Description of Project: Construction of New Mechanic's Shop P4

# AIA® Document A101® – 2017

Construction of New Mechanic's Shop – Precinct No. 4
1051 N. Doolittle Rd
Edinburg, Texas 78542

ERO Architects
300 S. 8th St.
McAllen, Texas 78501
956-661-0400

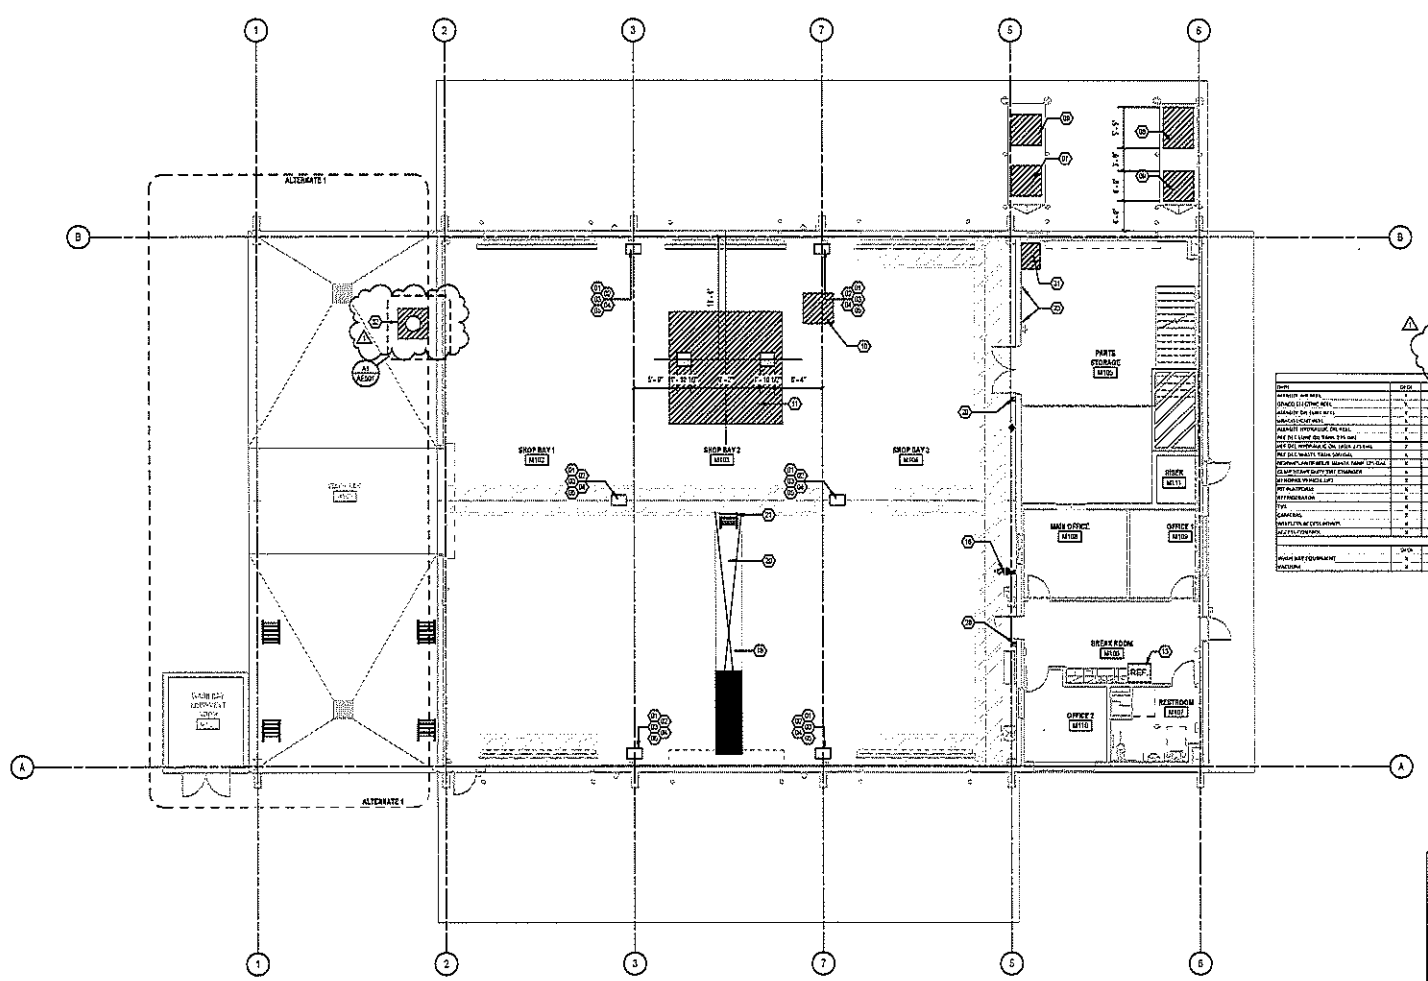
19. On sheet AE103 – Equipment Layout Plan, "SHEET KEYNOTES" has keynote "31" listed twice. Which "31" location is correct on the plan?
**ERO Response: Refer to sheet AE103R attached.**

Item No. P03. Sheet AE103 – Delete in its entirety
**Replace with revised Sheet AE103R. Refer to attached.**

1 ELECTRICAL POWER PLAN - 1ST FLOOR
1/8" = 1'-0"

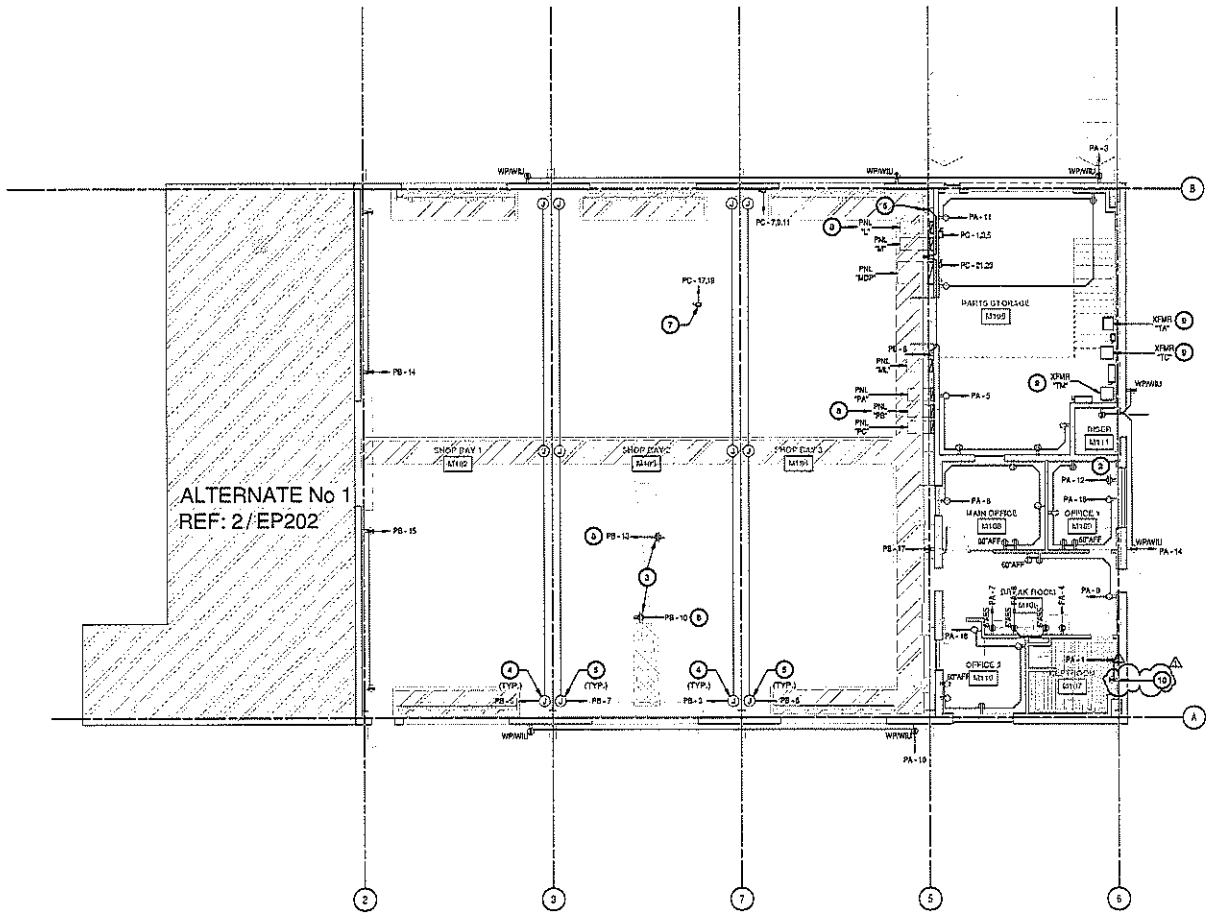
ITEM 2. Refer to Sheet EP201
a. Added keynote 10.
b. Added Receptacle to power the towel dispenser.

| SHEET: | C01-01 |

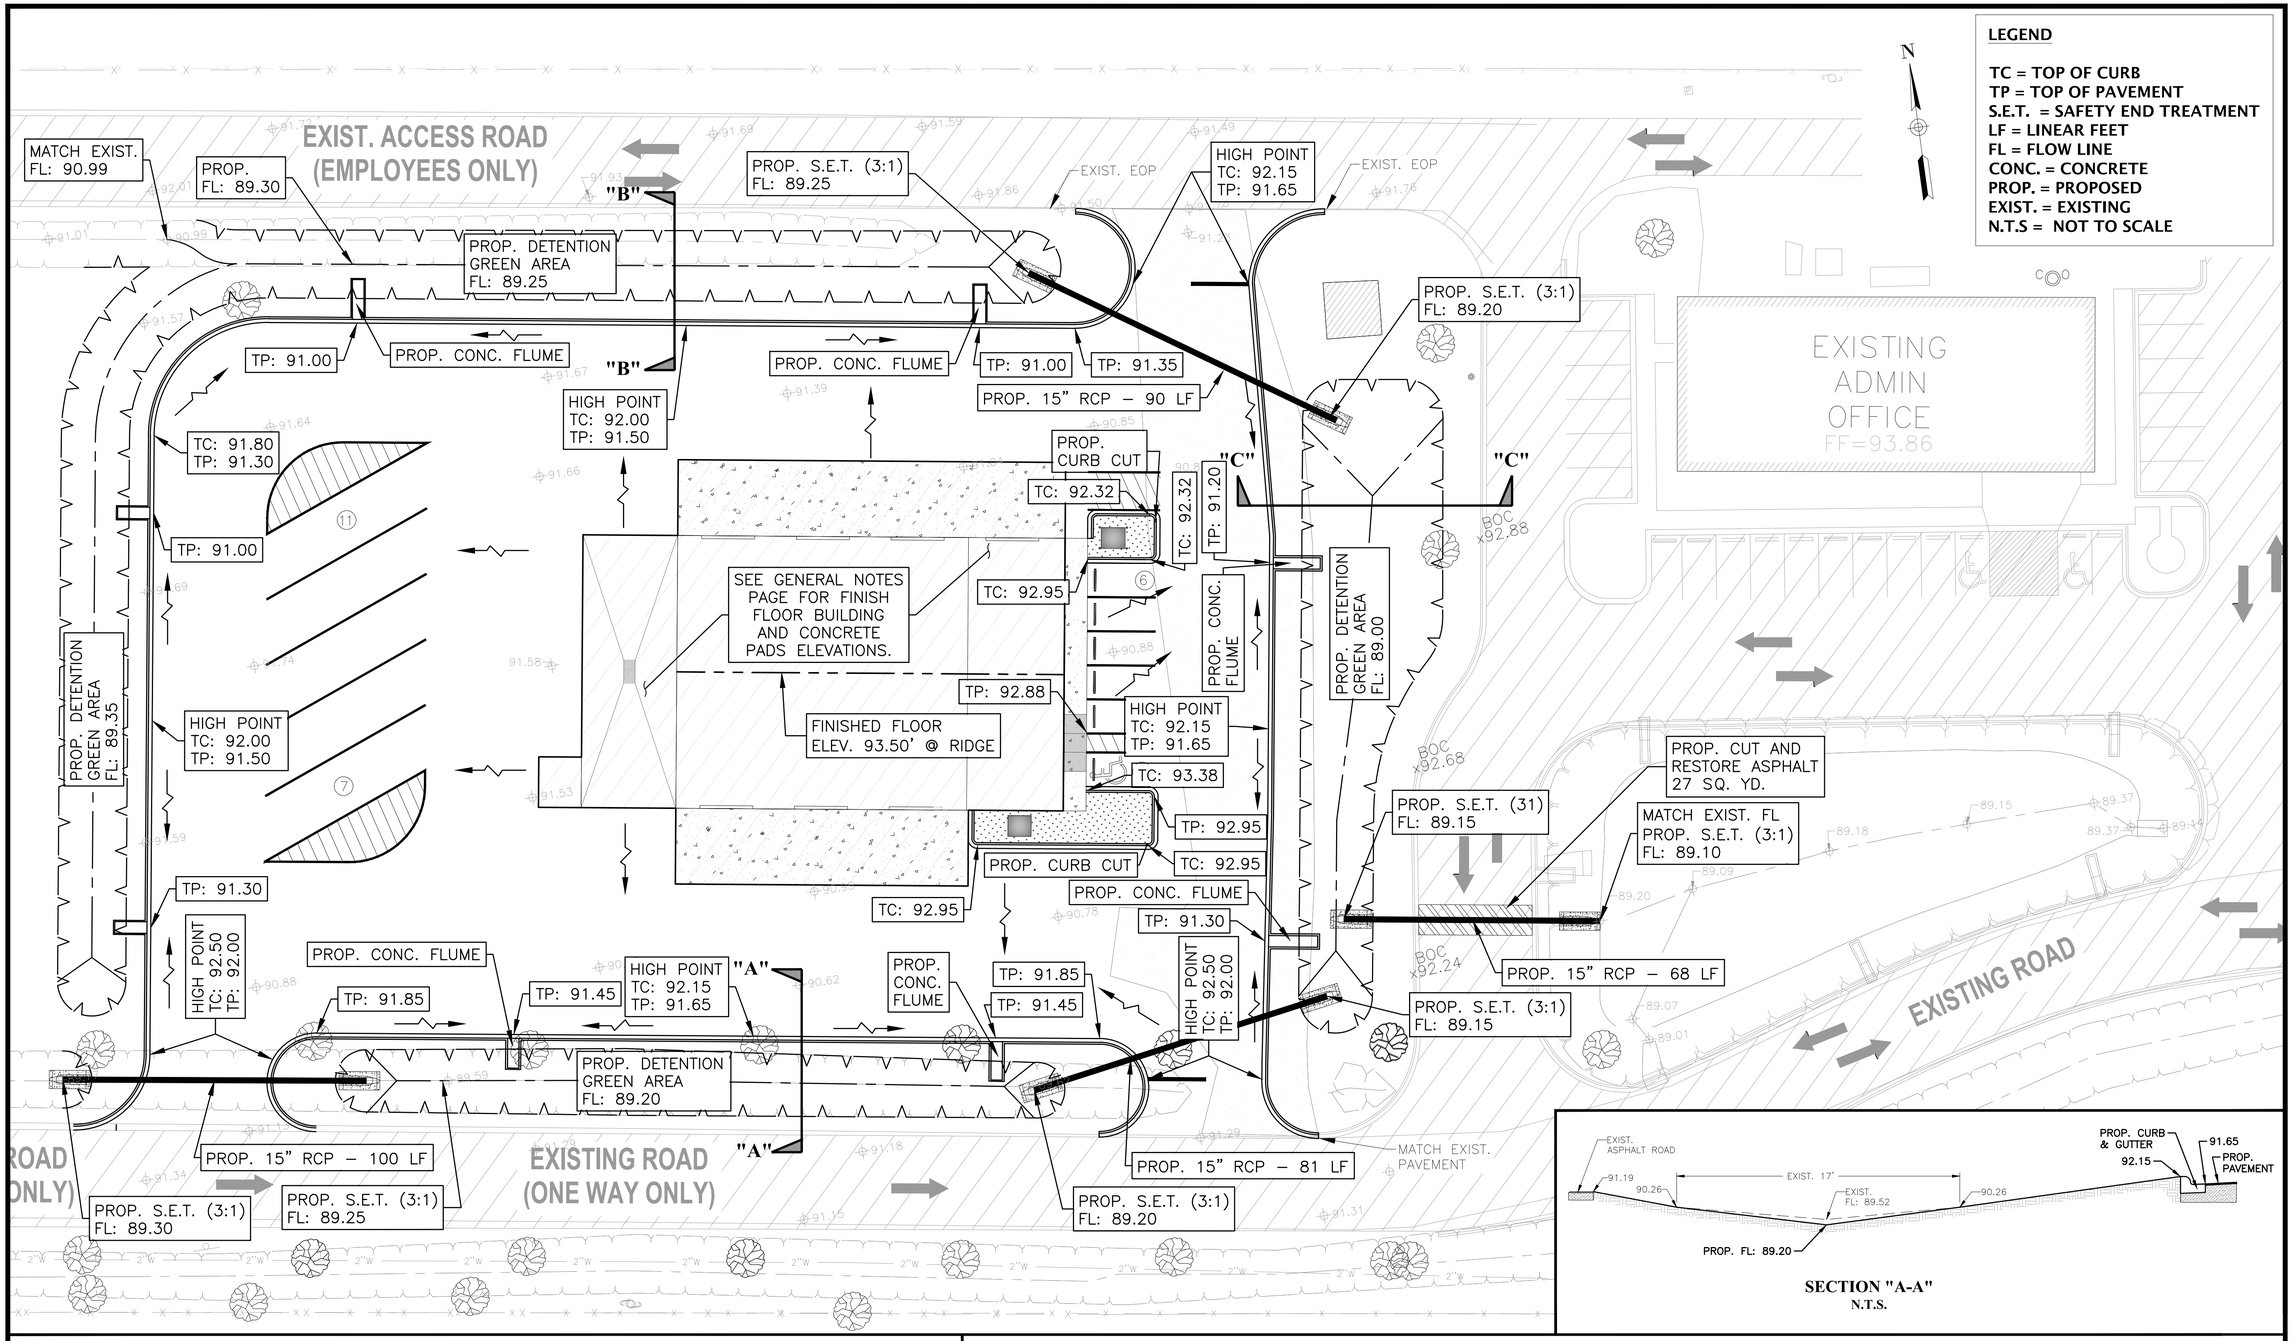
15. Plan sheets C01-02 and AS100 shows wash bay as base bid, but sheet SB101 it shows as Alternate #1. Verify. Provide type of surface at wash bay (grass, asphalt, or concrete) for base bid.
    **ERO Response:**
    - **Refer to sheet AE101 for clarification of Alternate No. 1.**
    - **Alternate No. 1 will require a concrete pad, if not accepted, asphalt will be required as defined in Civil sheets.**

**A10** | MEZZANINE FRAMING PLAN
1/8" = 1'-0"

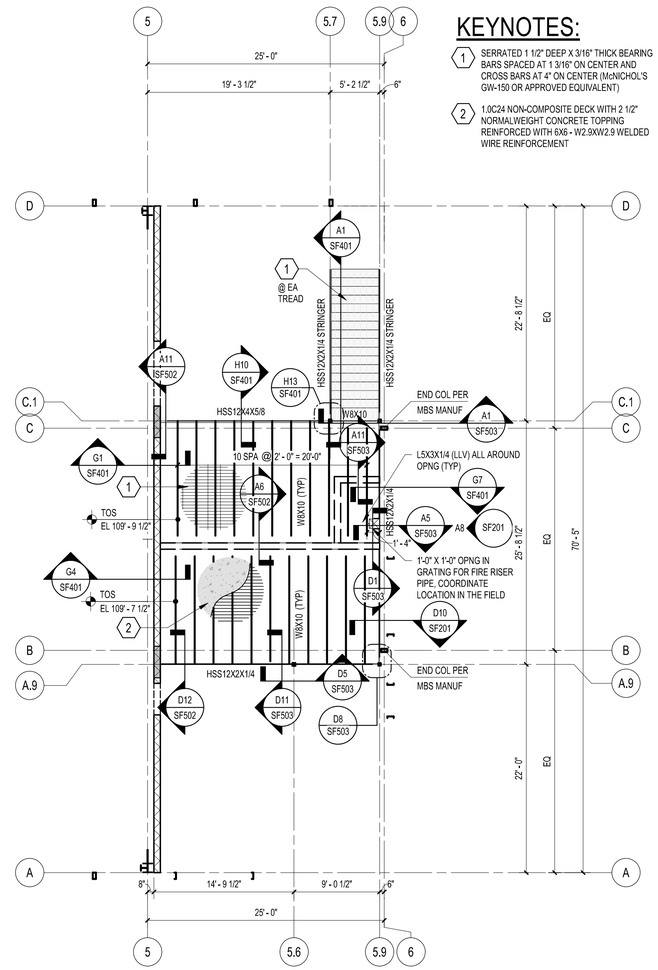
5. On sheet SF401 – A10 Mezzanine Framing Plan, Details G4/SF401, E9/SG011, A6/SF502, refer to the bearing support of the mezzanine frame and call out for "CONC BRG BLOCK". Will this be formed concrete? Or will it be a masonry lintel as shown on detail A9/SG011?

## F1 | SOUTH ELEVATION
1/8" = 1'-0"

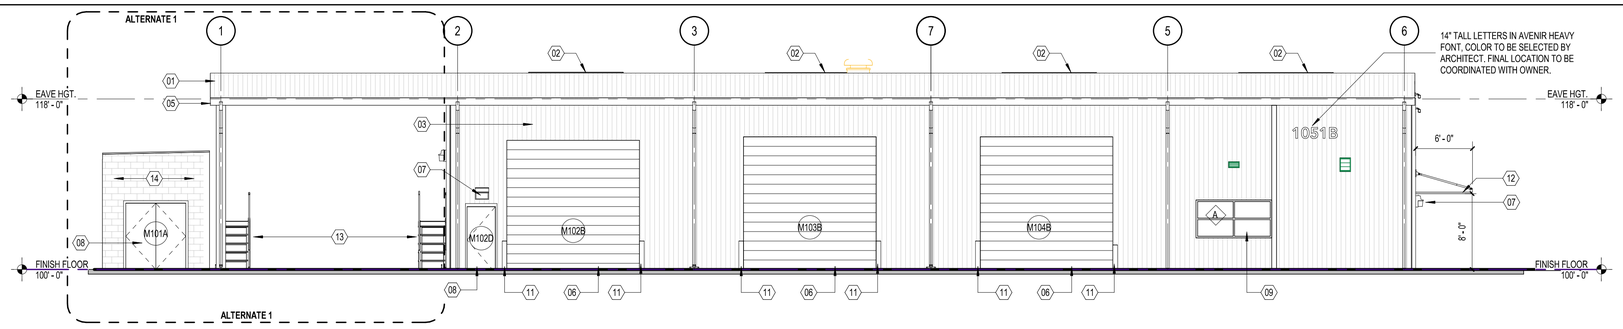
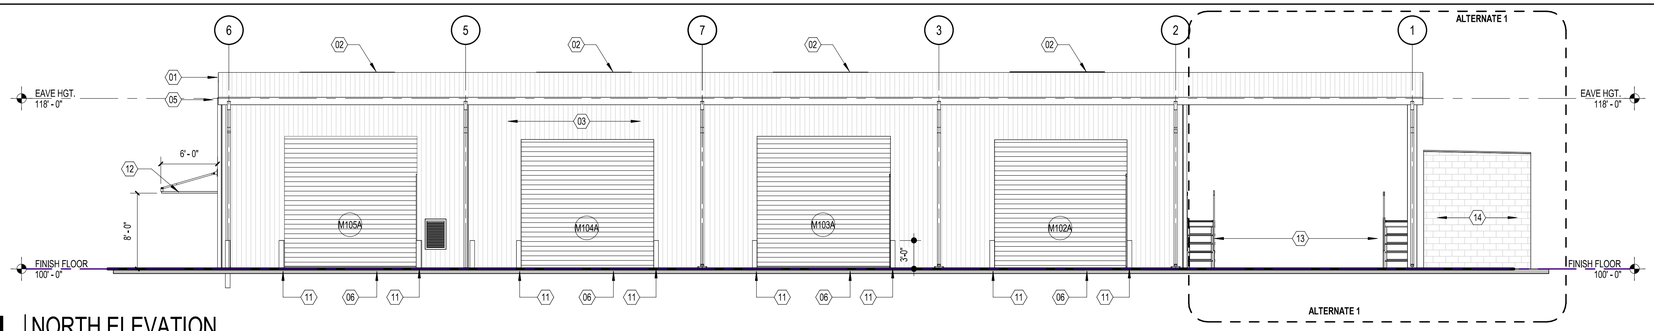
3. Sheet AE201 Elevation F1 and C1 - Can you please provide additional information on the exterior letters? What kind of material is required?
   **ERO Response: Refer to RFI Question 2.**
